## **ADDENDUM NO. 1**

**Project:** Wayne State College Willow Bowl Renovation

**Project No.:** L11045

**Date:** 21 May, 2012

REF. SHT#     C1.0      
DETAIL 1

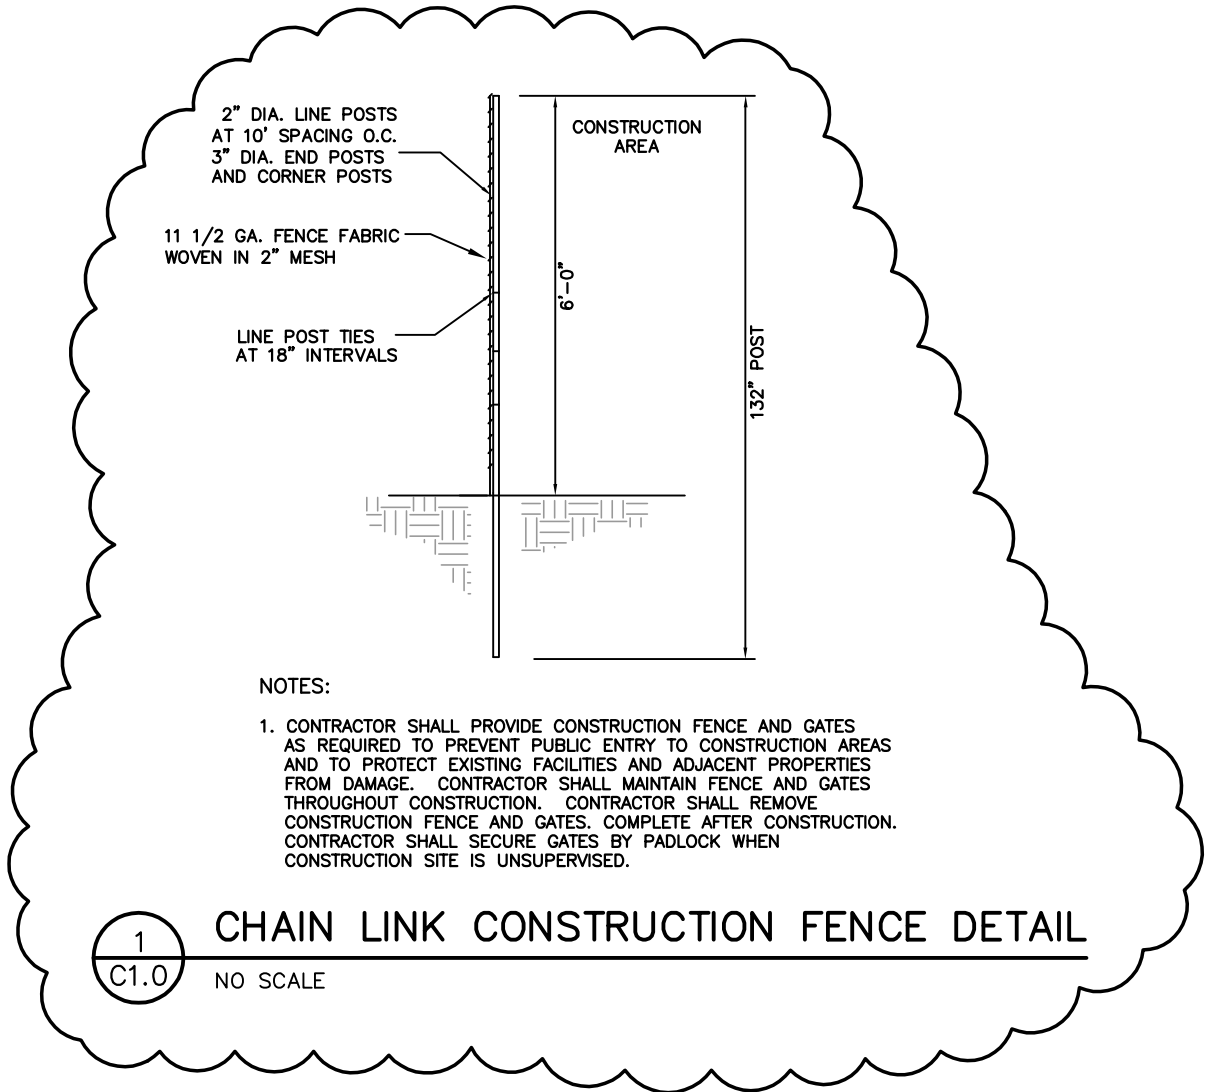
2. Delete: Note 8, Sheet C1.0; in its entirety
  3. Add New Note: Note 8, Sheet C1.0; Remove area inlet, contractor shall abandon 36" storm sewer pipe or fill 36" storm sewer pipe with flowable fill material. Plug ends of pipe. No trees or other utilities shall be disturbed.

REMOVAL INFORMATION	
(NO.)	DESCRIPTION
1	PROTECT EXISTING TREE
2	REMOVE EXISTING TREE STUMPS
3	PROTECT EXISTING UTILITY
4	REMOVE EXISTING RETAINING WALL
5	REMOVE EXISTING CONCRETE BENCH AND STEPS
6	REMOVE CONCRETE PAD
7	RELOCATE EXISTING ELECTRICAL LINES, SEE ELECTRICAL PLANS FOR FURTHER INFORMATION.
8	REMOVE AREA INLET, CONTRACTOR SHALL ABANDON 36" STORM SEWER PIPE OR FILL 36" STORM PIPE WITH FLOWABLE FILL MATERIAL. PLUG ENDS OF PIPE. NO TREES OR UTILITIES SHALL BE DISTURBED.

REF. SHT#     C1.0      
 DETAIL 2

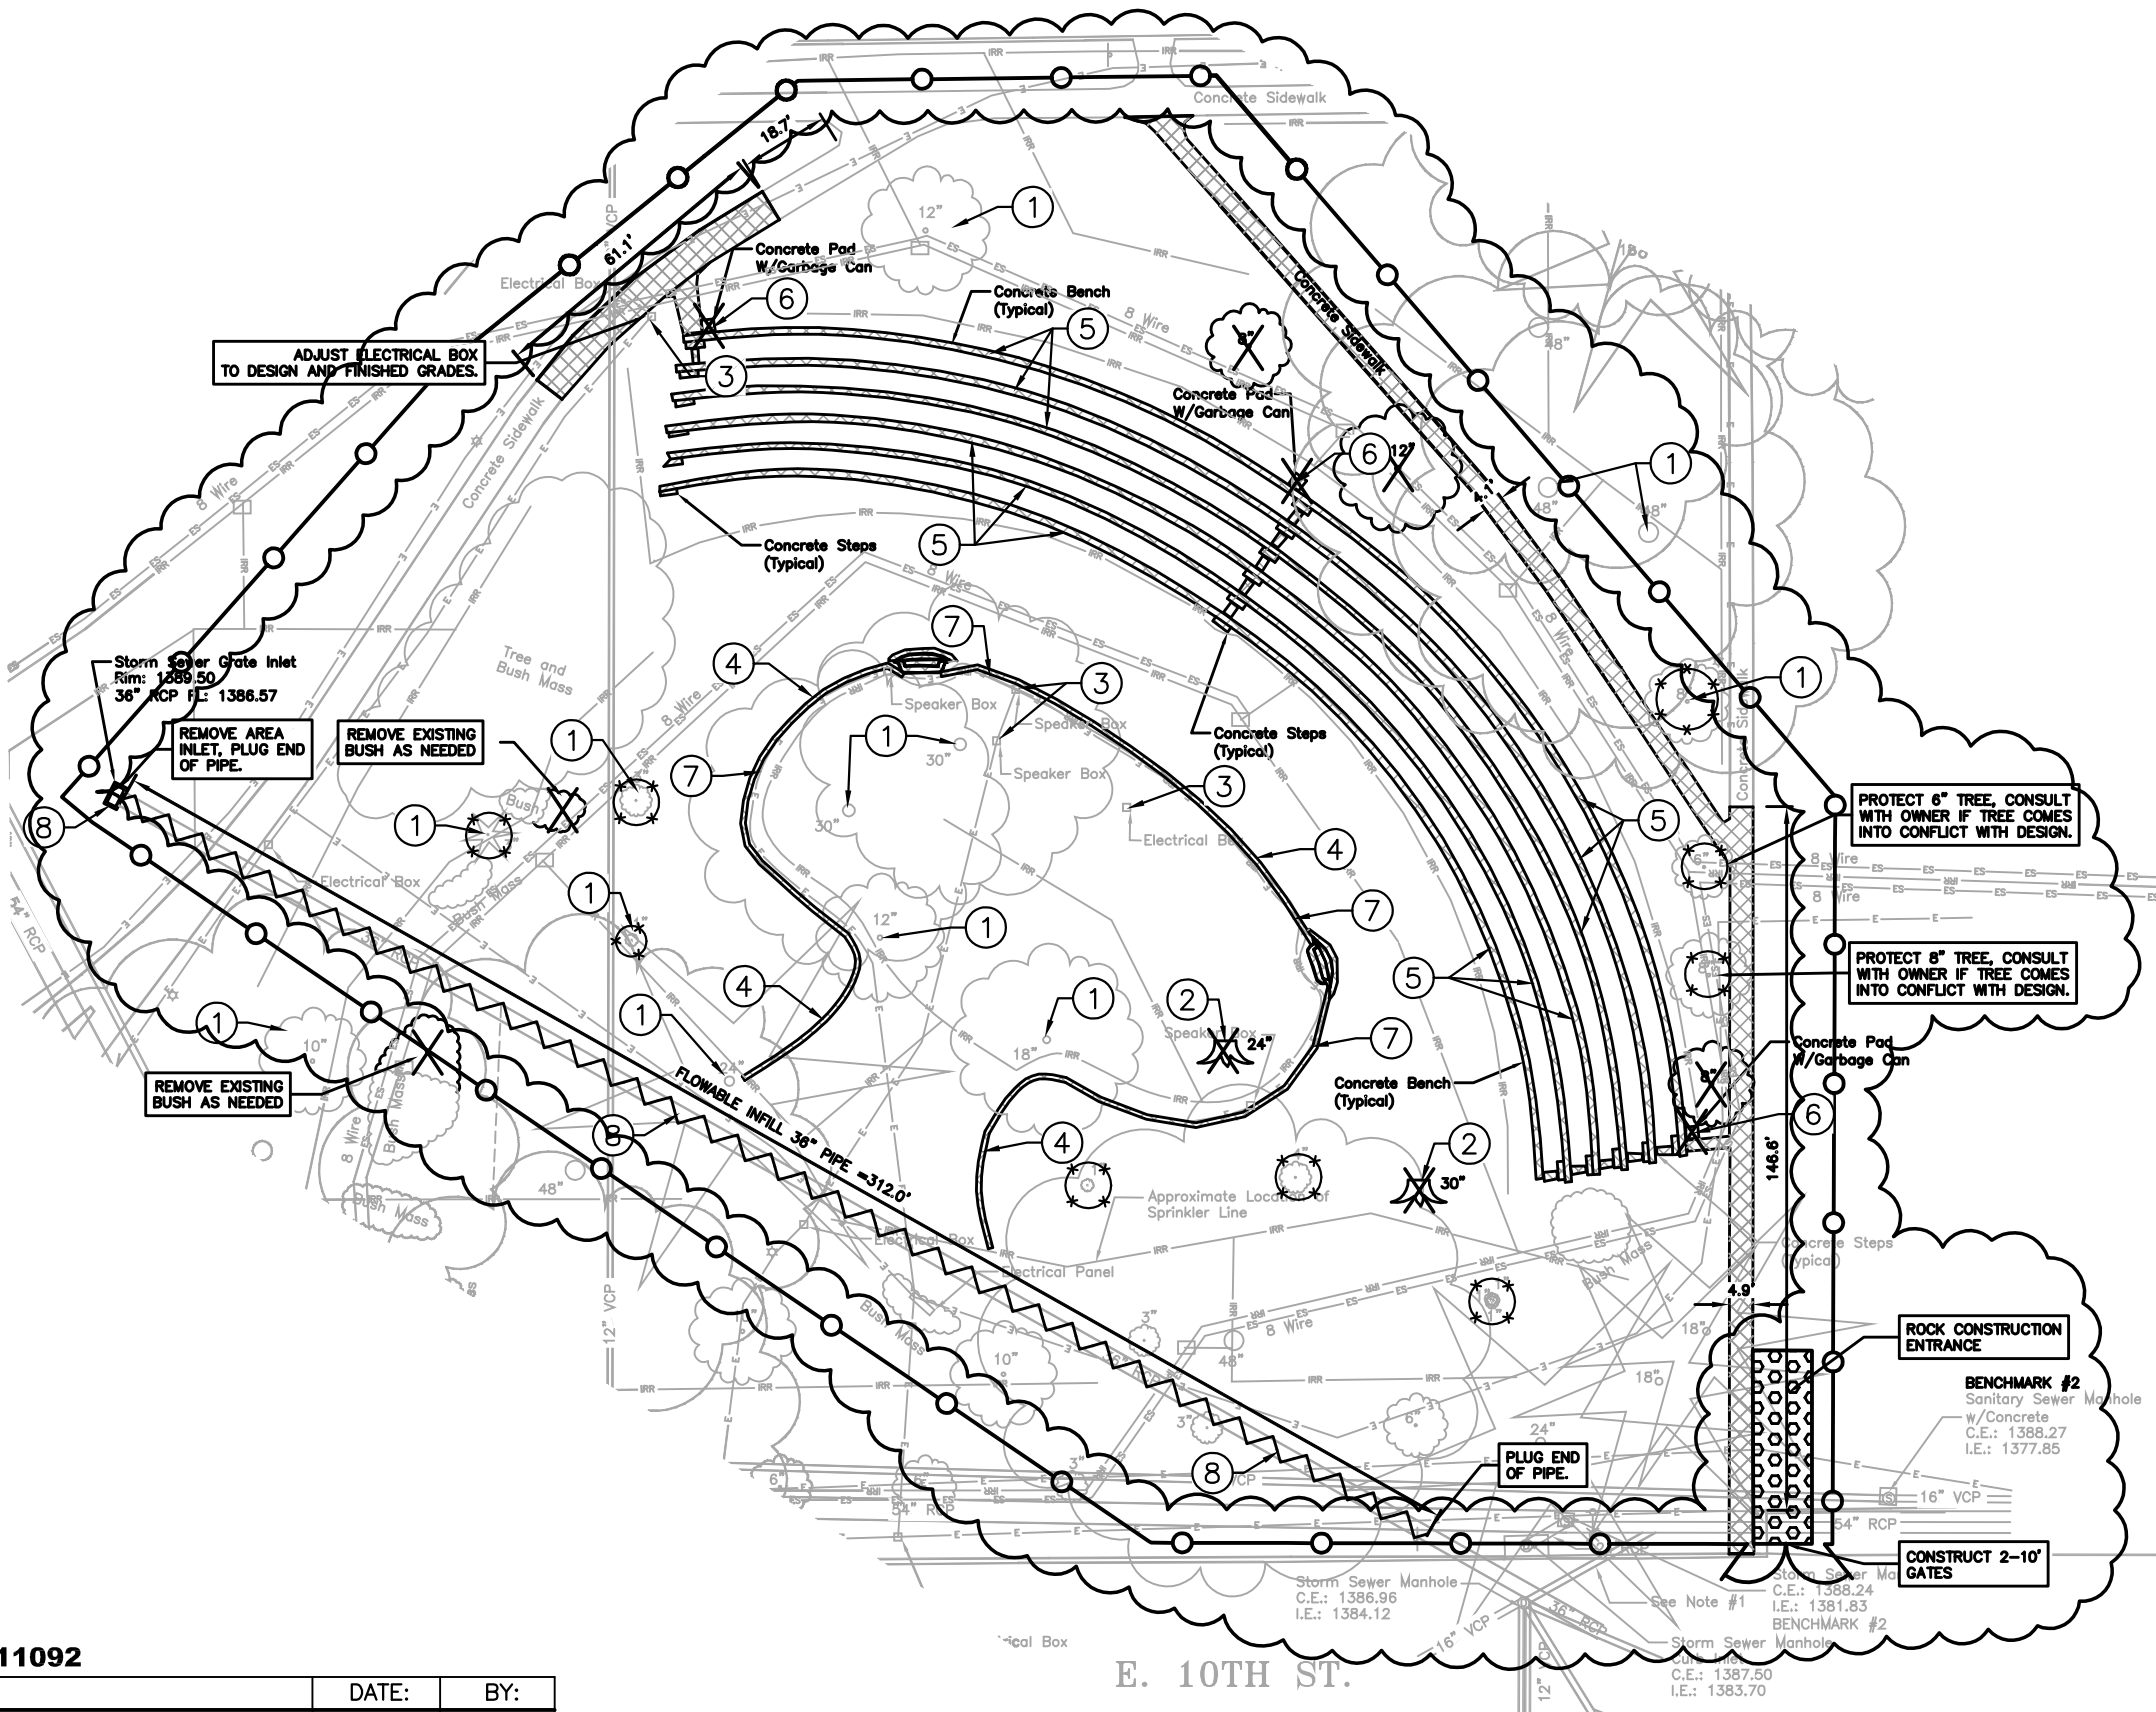
1. Reference Sheet C1.0
  - A. See attached drawing C1.0-Detail 1 and Detail 2.
    1. Construction chain link fence detail has been added. Construction fencing shall be installed as first order of work. Verify locations with Owner. Fencing shall be installed to prevent any access to construction area. Unattended gates shall be locked. Contractor shall obtain a paddle lock from Owner. The Contractor shall construct construction fence and gates and remove construction fence and gates

after construction is completed. Contractor shall repair any holes or damage caused by the construction or removal of the fence and gates at the Contractors expense.

REF. SHT#     C2.0      
DETAIL 4

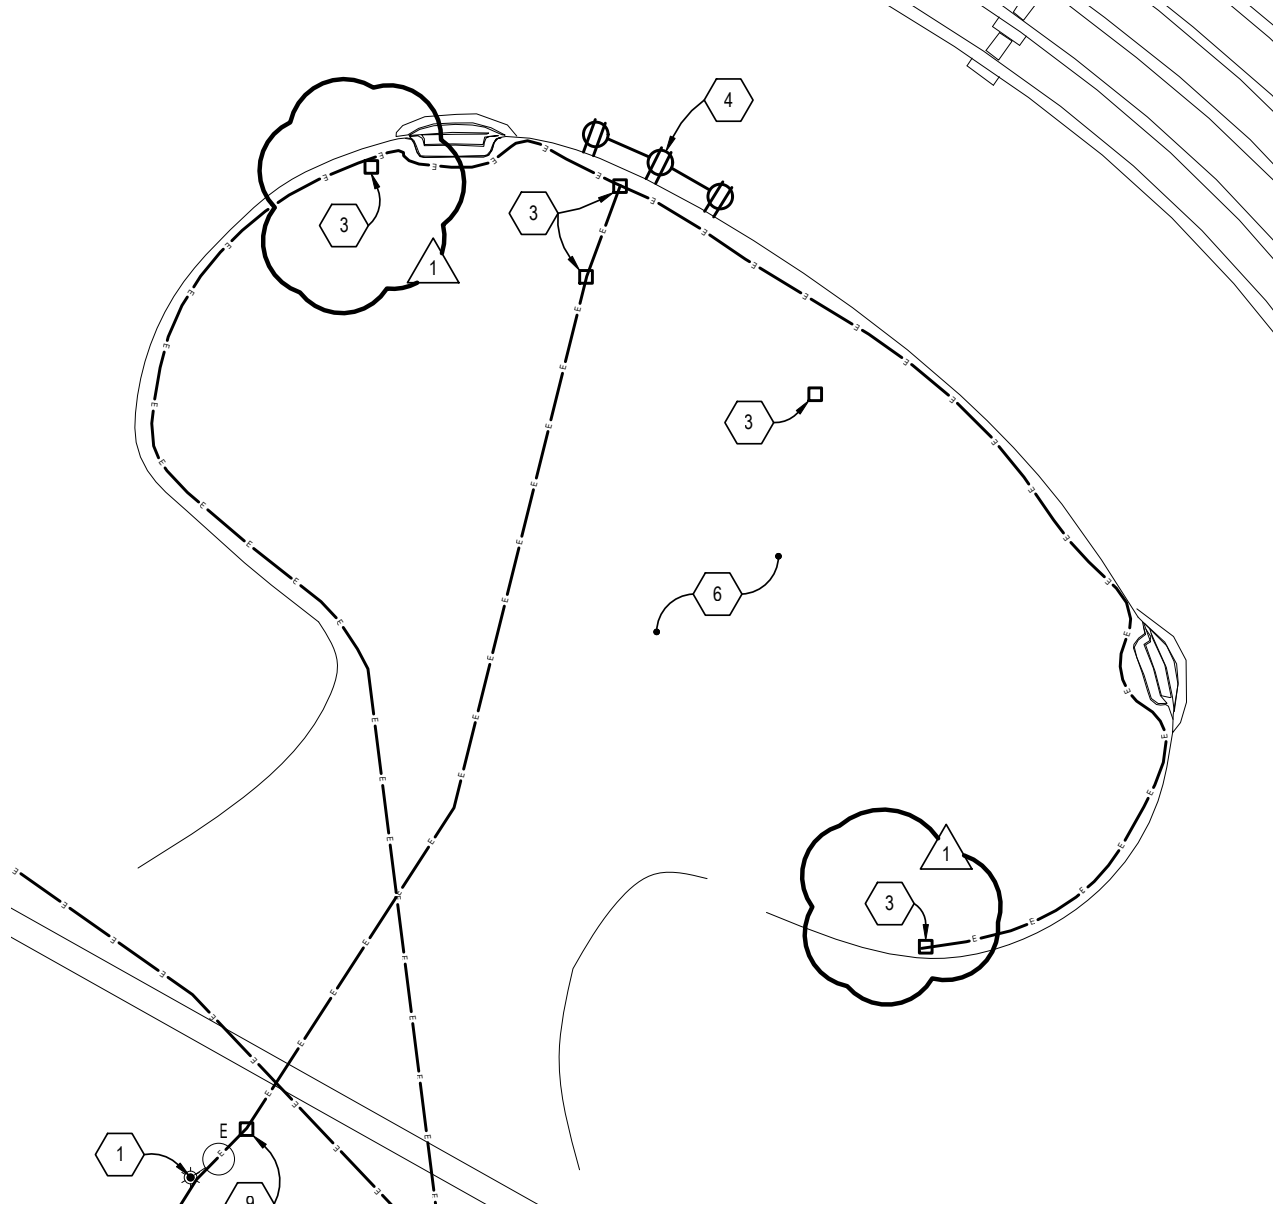
2. Reference Sheet C2.0
    - A. See attached drawing C2.0-Detail 4.
      1. Delete: Wrapped in Filter Sock from Detail 2/C2.0; Collection Trench.
  3. Add: Sheet C1.5, Stormwater Pollution Prevention Plan in its entirety.

ISSUED FOR:	DATE:	BY:
REVISED NOTE, REMOVED "WRAPPED IN FILTER SOCK"	05/18/12	REGA

DETAIL E0.1R

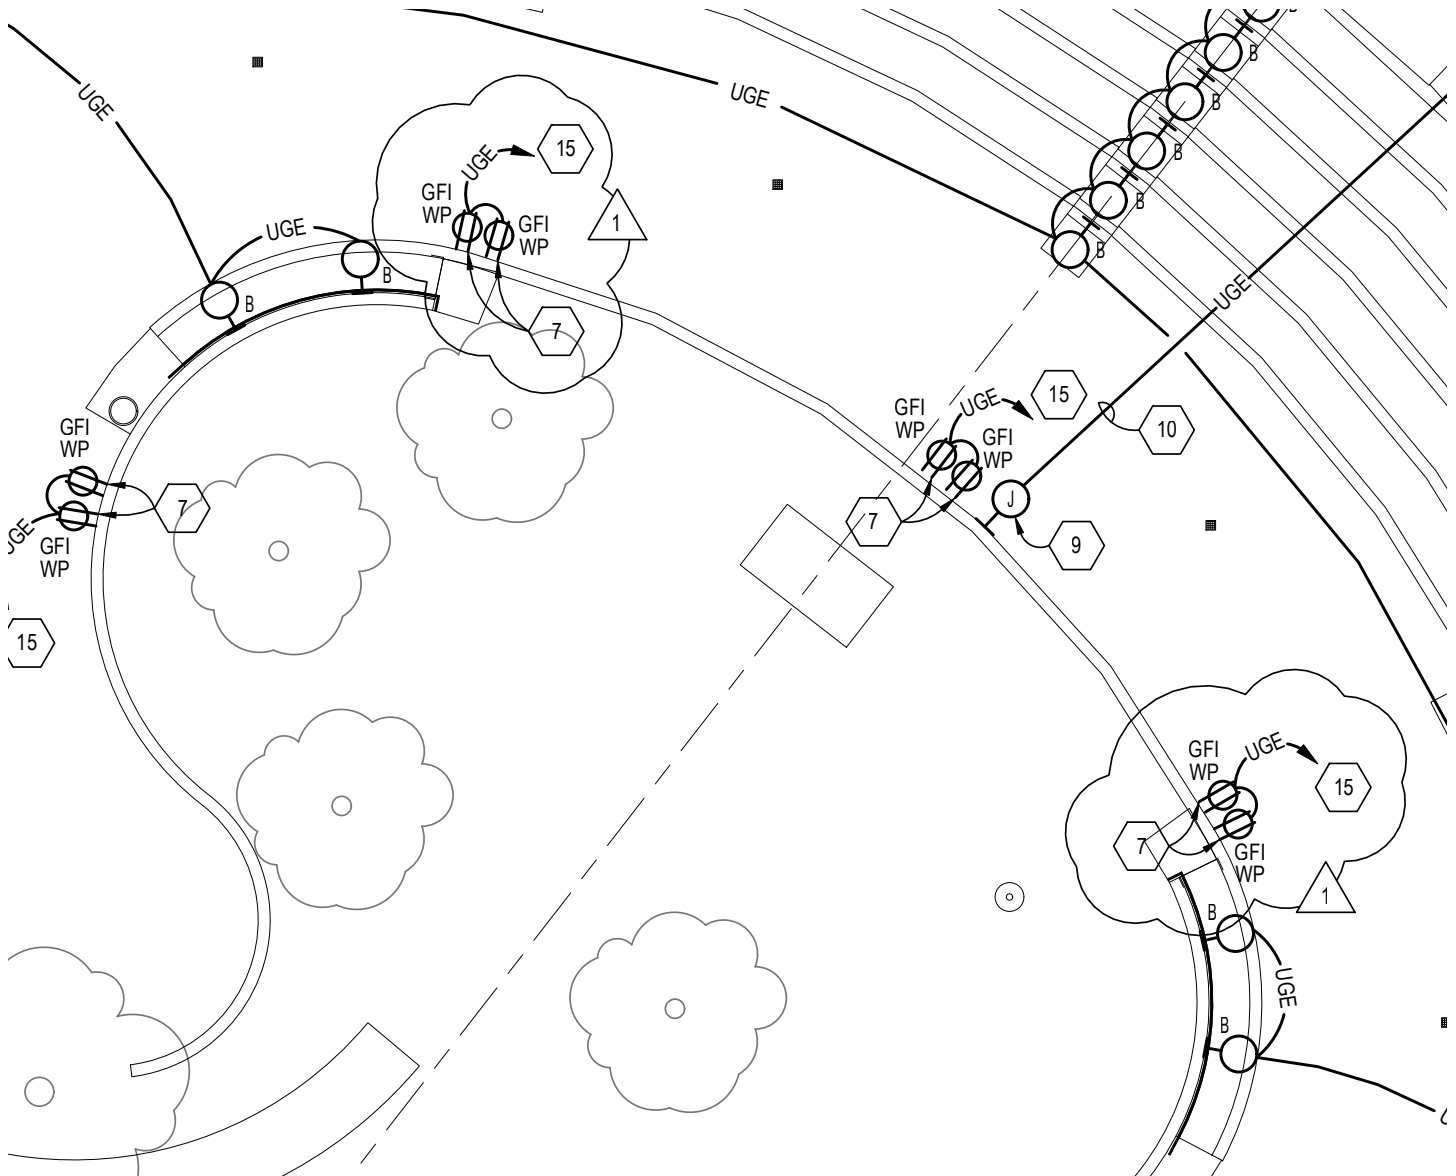
4. Add: Sheet C1.6, Stormwater Pollution Prevention Notes in its entirety.
  5. Reference Sheet E0.1
    - A. See attached supplemental detail E0.1R.
      1. E0.1R delineates revised location of the existing speaker boxes.

- 3
 EXISTING IN GRADE COVERED HANDHOLES WITH RECEPTACLES AND SPEAKER CABLING. RECEPTACLE CIRCUITS AND SPEAKER CABLE ORIGINATING FROM AREA PANELBOARD SOUTH OF STAGE. REMOVE ALL RECEPTACLES AND ASSOCIATED WIRING. EXISTING BOX AND SPEAKER CABLING TO REMAIN. RELOCATE THE BOXES CURRENTLY LOCATED ALONG THE EDGE OF THE STAGE WALL TO THE STAGE SIDE OF THE NEW WALL LOCATION. REROUTE CONDUIT, EXTENDING WITH NEW AS NECESSARY.
- 1
